# Maine Yankee

MN-96-145

Subject: Response to USNRC Request for Information (RAI) - Maine Yankee SBLOCA Analysis

**Non-Proprietary Responses<sup>1</sup>**  
**to**  
**USNRC RAI on SBLOCA Analyses**

Figure 4-6 Peak Cladding Temperature for  
Time Step Sensitivity

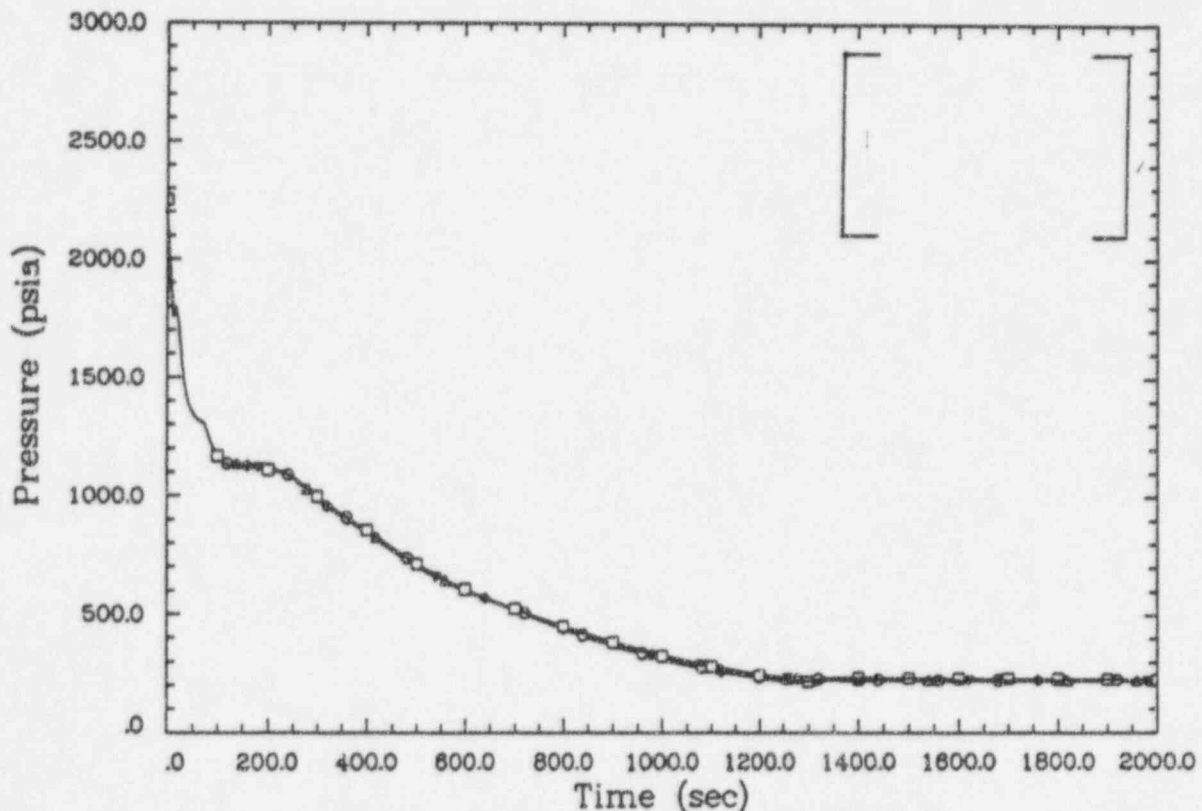
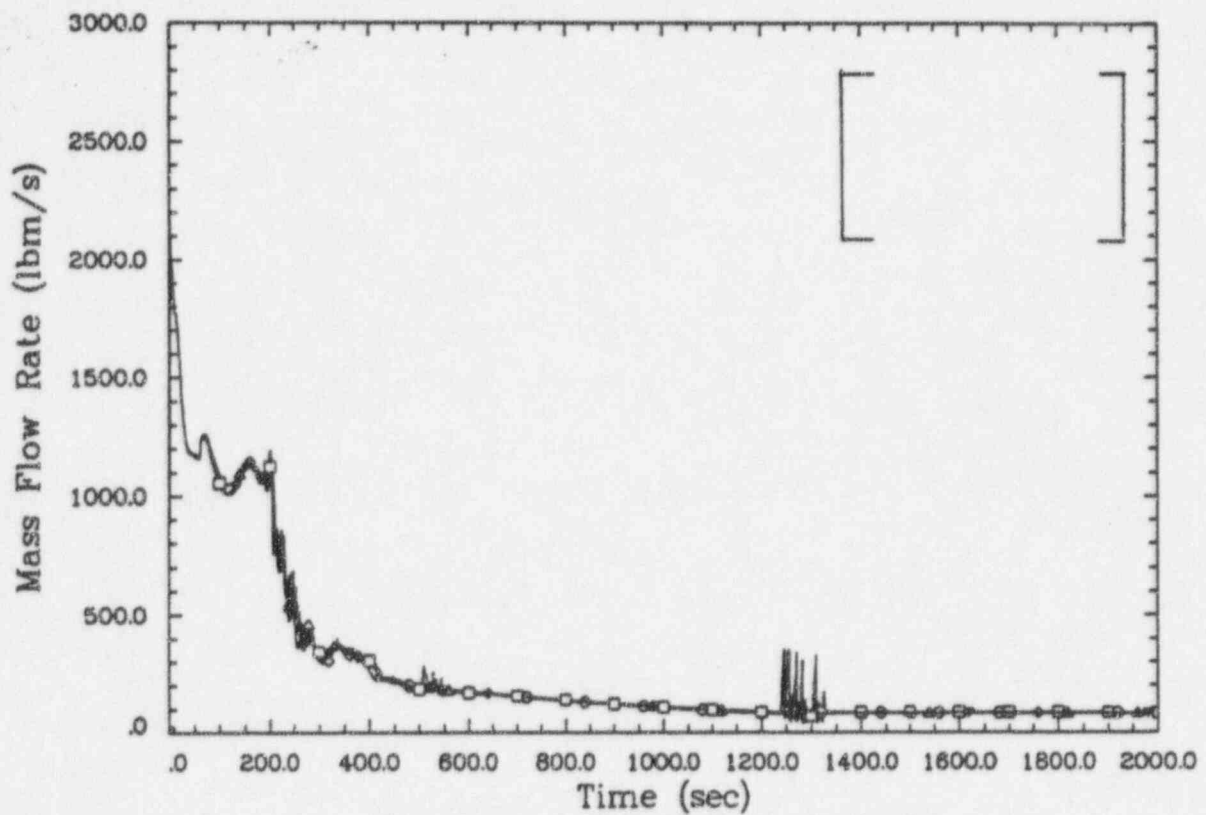
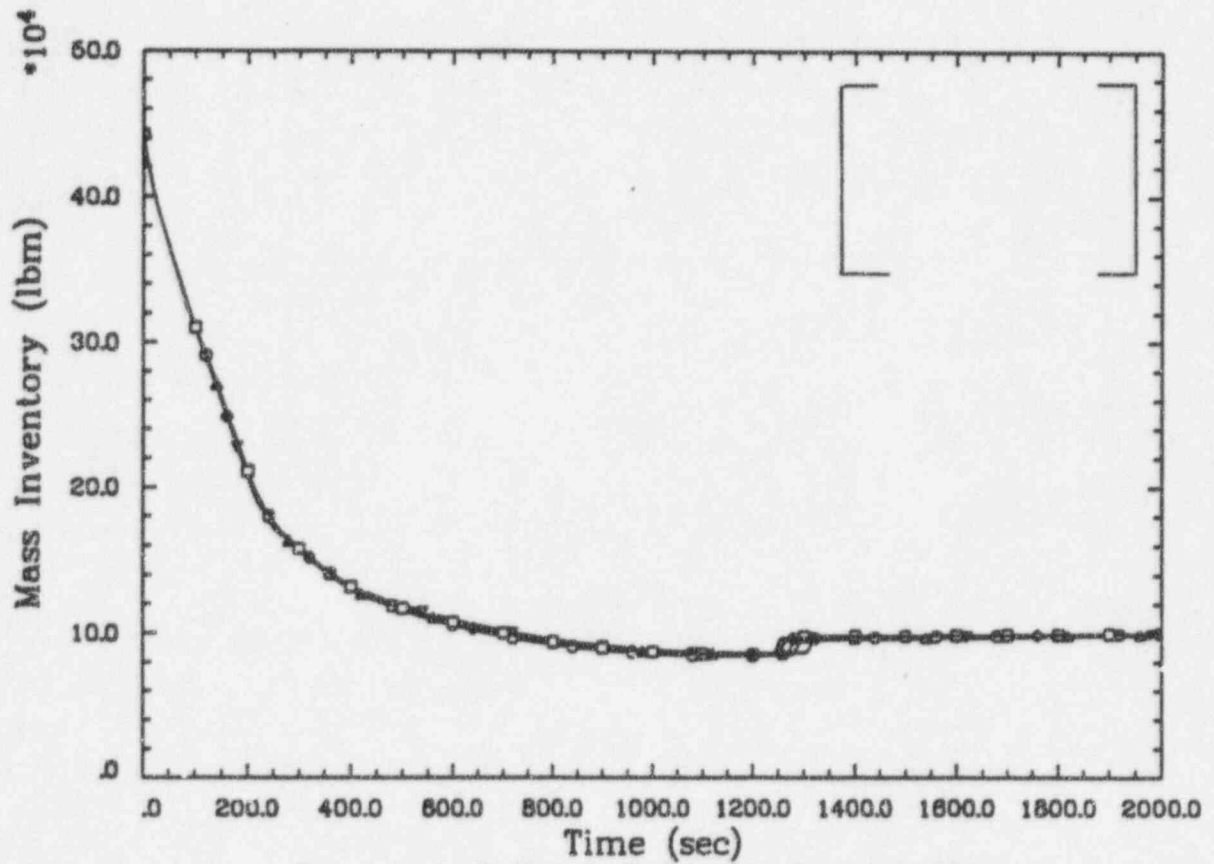
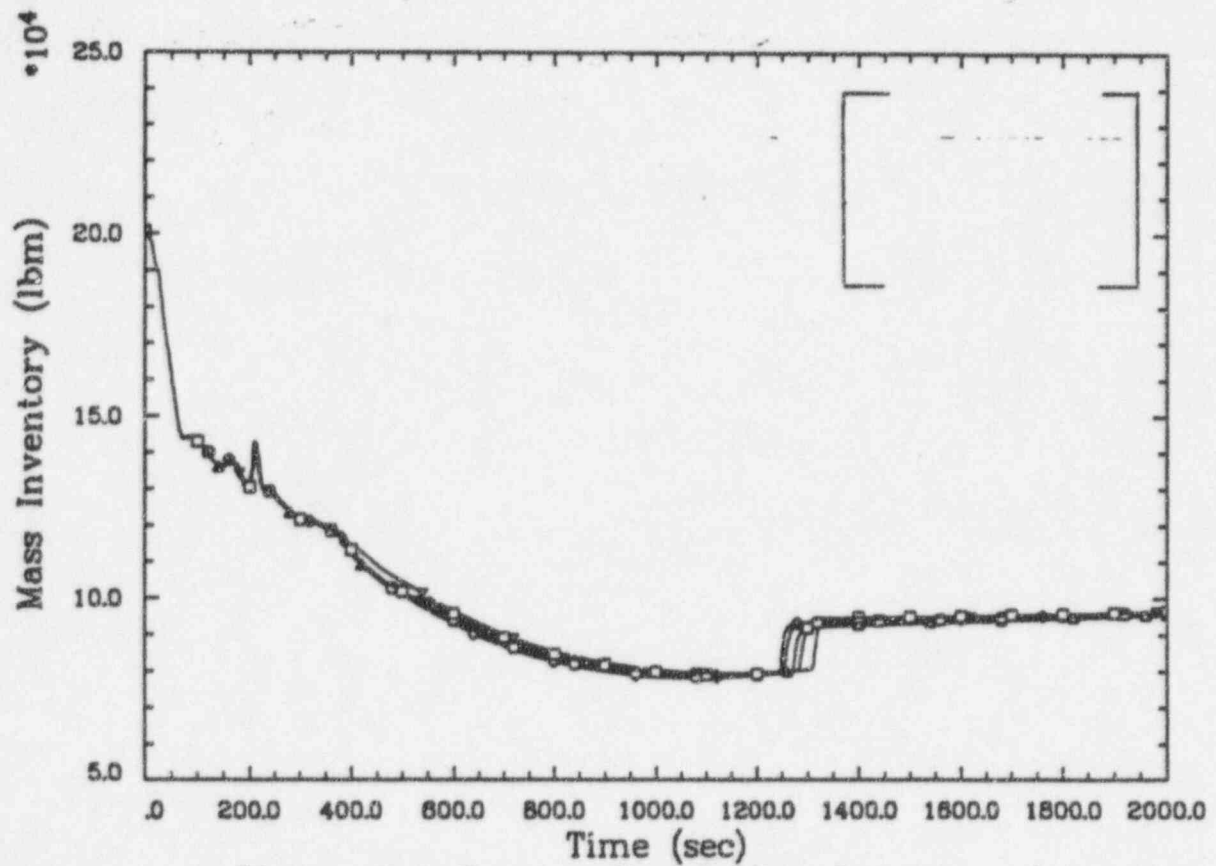
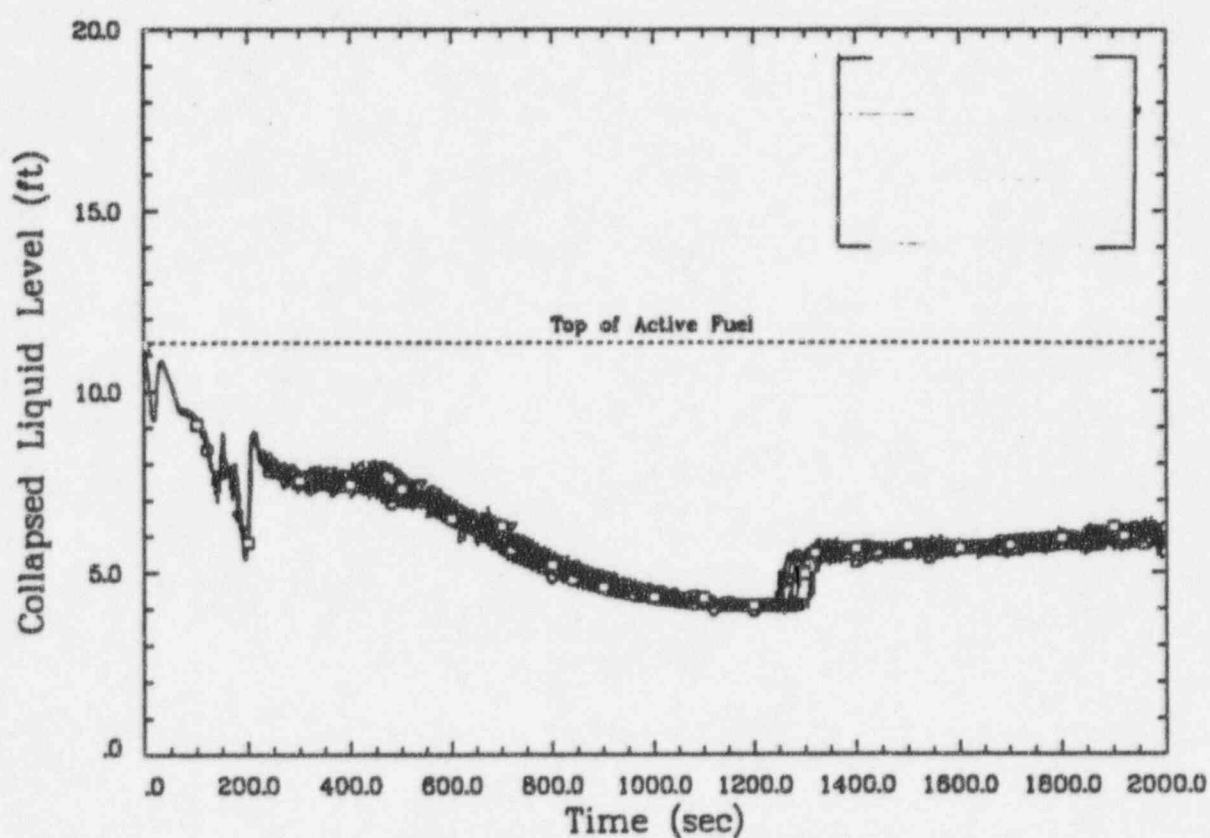
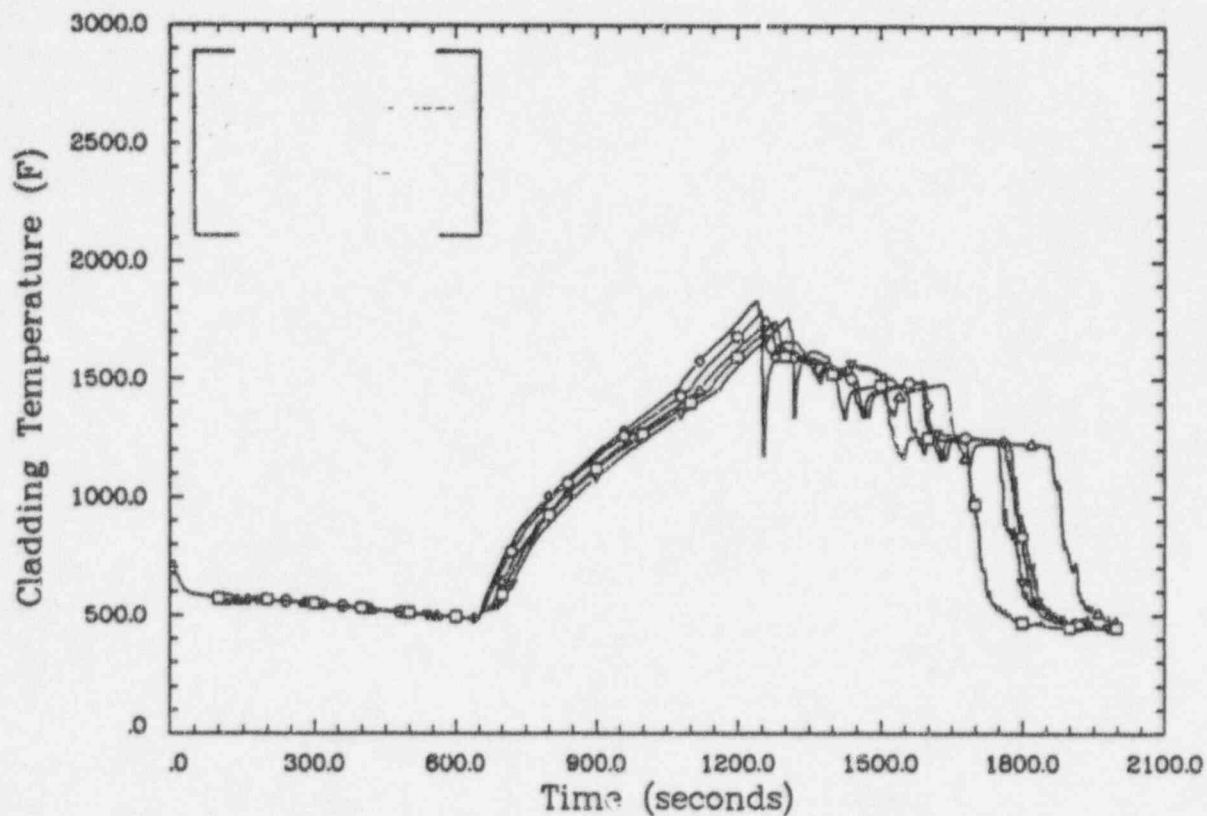
Some of the correlations (such as the Baker-Just metal-water reaction correlation) used in ANF-RELAP and TOODEE2 are very sensitive to time-step selection. The metal-water reaction rate is calculated at the beginning of the time-step. This means that during a temperature rise, the metal-water reaction rate is systematically underpredicted. Explain how the convergence of the equations is achieved. Quantify the energy error from this systematic underprediction of the metal-water reaction rate for the Maine Yankee application.

Also, the time-step will affect the accuracy of the solutions to the differential equations used in ANF-RELAP for system response calculations and in TOODEE2 for rod heatup calculations. The licensee is requested to provide a discussion of the method of selection of the time-step used in ANF-RELAP and TOODEE2 for the Maine Yankee SBLOCA analysis. This discussion should include the results of time-step sensitivity calculations to show that for a time-step used in the licensing applications, the mass and energy calculations will obtain convergent solutions, and further changes (either increase or decrease) in the time-step will not significantly change the calculated PCT.

Time step sensitivity calculations for Maine Yankee have been performed in response to the NRC question to confirm the validity of using a time step size of [ ] seconds in ANF-RELAP. Time step sensitivity calculations were performed for the limiting case documented in EMF-96-043 (0.10 ft<sup>2</sup> break, 73% axial power shape, and minimum crossflow loss coefficient) using time step sizes of [ ] seconds. (The analysis documented in EMF-96-043 used a time step size of [ ] seconds.) Figures 4-1 through 4-5 compare primary system pressure, break flow rate, total primary system mass, reactor vessel mass, and core collapsed liquid level, respectively, for the various time step sizes analyzed. The system pressure, break flow rate, and total system mass are nearly direct overlays. There are only minor differences in reactor vessel mass and collapsed core liquid level due to minor differences in loop seal clearing behavior. The cladding temperature at the PCT location is plotted as a function of time in Figure 4-6 for the cases analyzed.

Since there is no particular trend in PCT with time step size over the range of time step sizes analyzed and the variation in PCT is relatively small, the case with a time step size of [ ] seconds reported in EMF-96-043 is a valid calculation of the PCT for the Maine Yankee plant.
